Well Name: BIG EDDY UNIT DI 30 WEST 15-20	Well Location: T20S / R31E / SEC 15 / SESE / 32.567897 / -103.848744	County or Parish/State: EDDY / NM
Well Number: 9H	Type of Well: OIL WELL	Allottee or Tribe Name:
Lease Number: NMLC065944A	Unit or CA Name: BIG EDDY	Unit or CA Number: NMNM68294X
US Well Number:	Operator: XTO PERMIAN OPERATING LLC

Type of Action: APD Change

Procedure Description: APD ID# 10400097414 XTO Permian Operating, LLC. respectfully requests approval to make the below listed changes to the approved APD – 1. Casing design to be changed from a 4-string engineered weak point design to a 4-string design with an uncemented annulus between 2nd intermediate and production casing strings 2. Associated changes required in the cement program & the mud circulation system as per the newly proposed casing design No changes requested to the SHL/BHL/take points, proposed MD/TVD and formation (pool). There will be no new surface disturbance. See attached drilling program for the updated casing design, cement program & mud circulation system. Attachments: Drilling Program, Non-API Spec document for Production Casing, Well bore diagram, Diverter Diagram, Flex Hose Variance, Spudder

[Figure E] 4 String – Uncemented Annulus between 2nd Intermediate and Production Casing Strings. (Reference R-111-Q: Exhibit B)

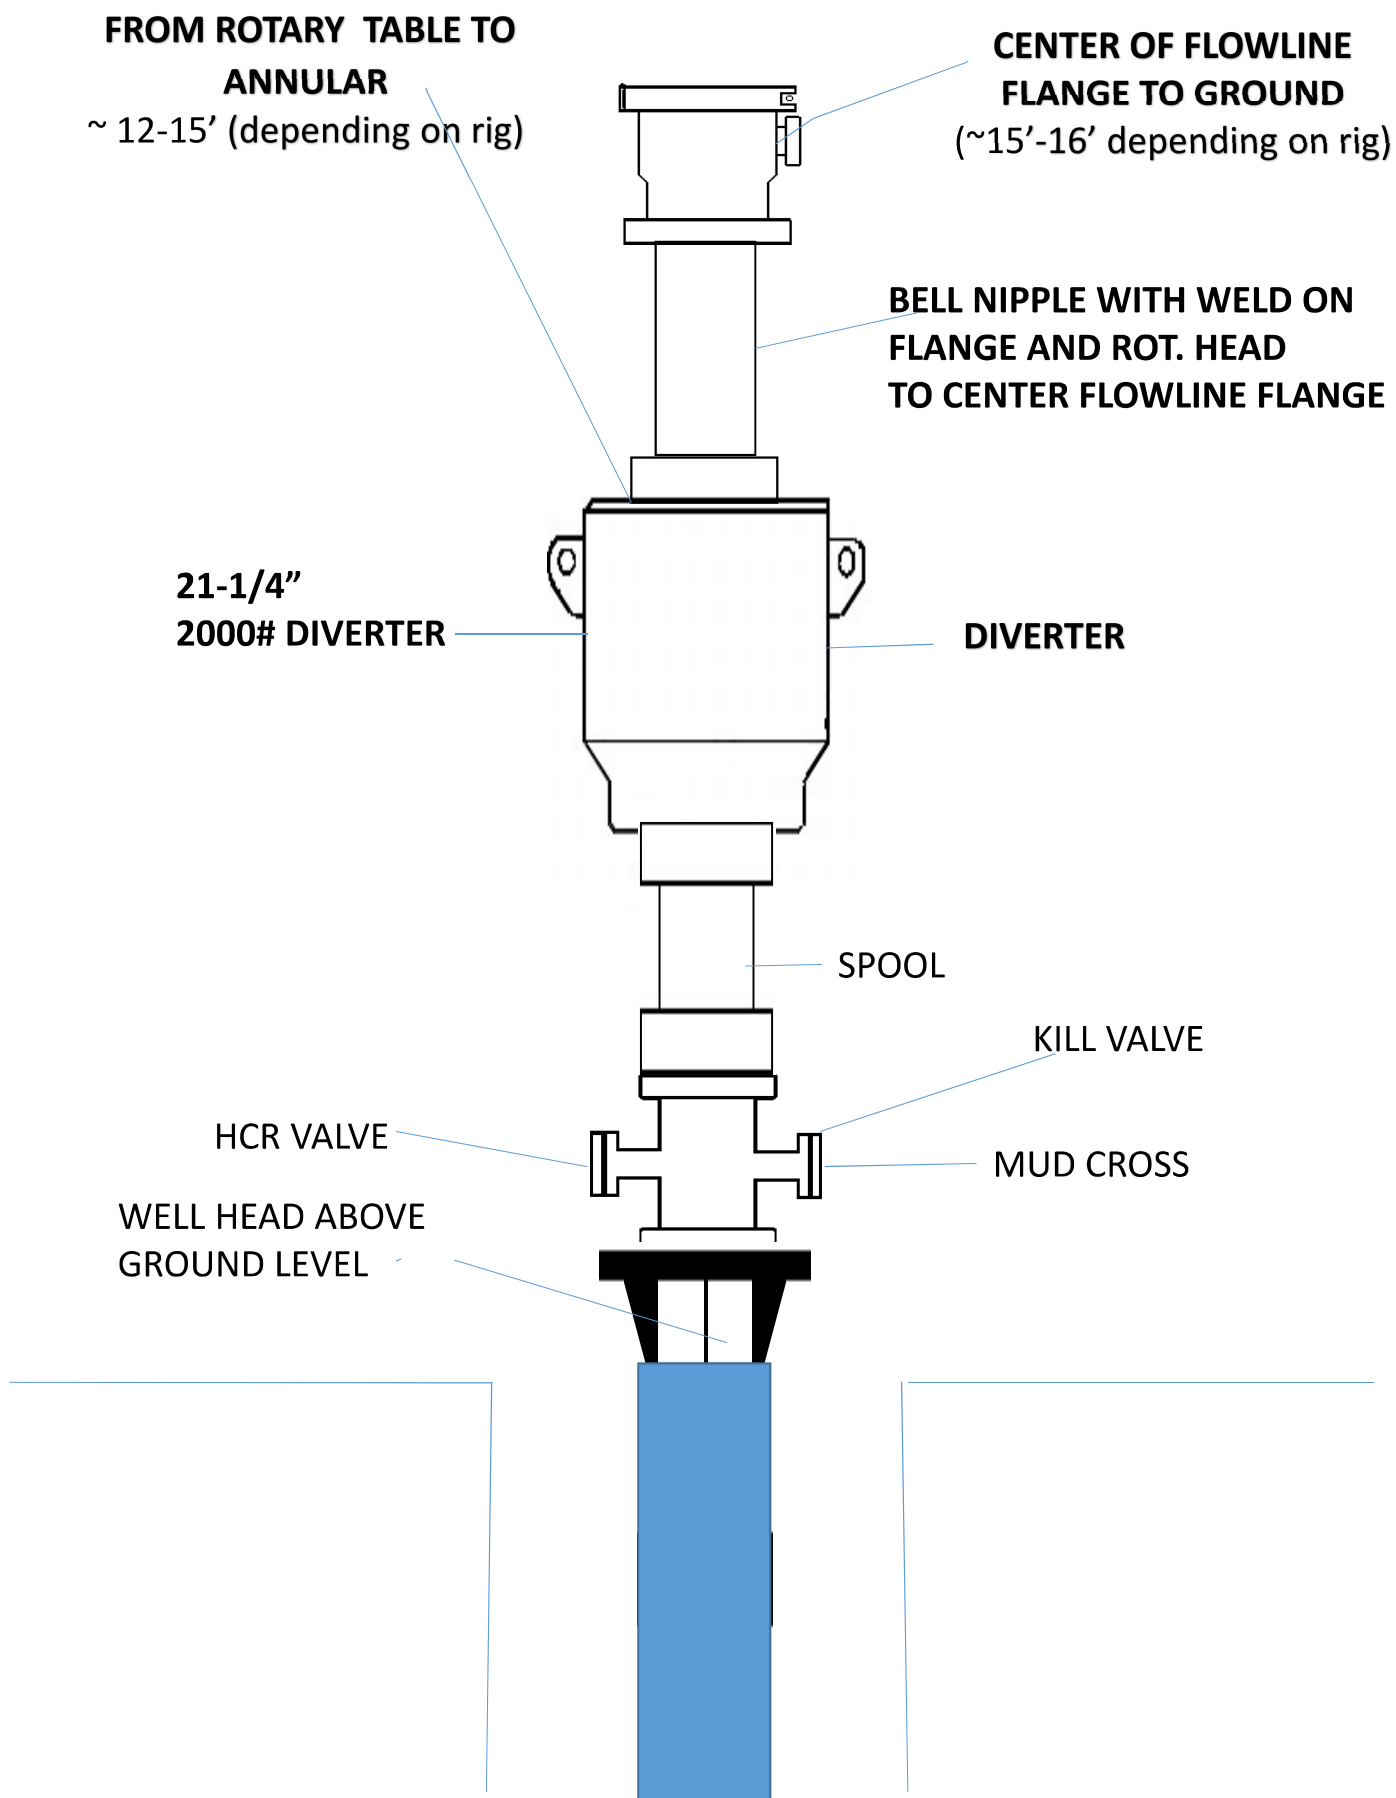
1. Casing design to be changed from a 4-string engineered weak point design to a 4-string design with an uncemented annulus between 2nd intermediate and production casing strings

2. Associated changes required in the cement program & the mud circulation system as per the newly proposed casing design

Open 2nd intermediate x production annulus to monitor during completion. In the event of production casing failure, pressure will either release at surface or into the formation below 2nd intermediate shoe in the Delaware Mountain group / Brushy Canyon relief zone (R111Q Figure E)

- Alignment with KPLA requirements per schematic below, with open 2nd Int x production casing design and utilizing new casing that meets API standards.

- Production casing will consist of a primary cement job with TOC at the top of the Brushy Canyon formation within the Delaware Mountain Group with 0% excess and well below the minimum of 500' from Intermediate 2 casing shoe.

4. The minimum required fill of cement behind the 6 inch production casing is:
 - Cement should tie-back **500 feet** into the previous casing but not higher than **USGS Marker Bed No. 126. Operator must verify top of cement per R-111-Q requirements.** Submit results to the BLM. If cement does not circulate, contact the appropriate BLM office. **Wait on cement (WOC) time for a primary cement job is to include the lead cement slurry due to cave/karst, Capitan Reef, or potash.**
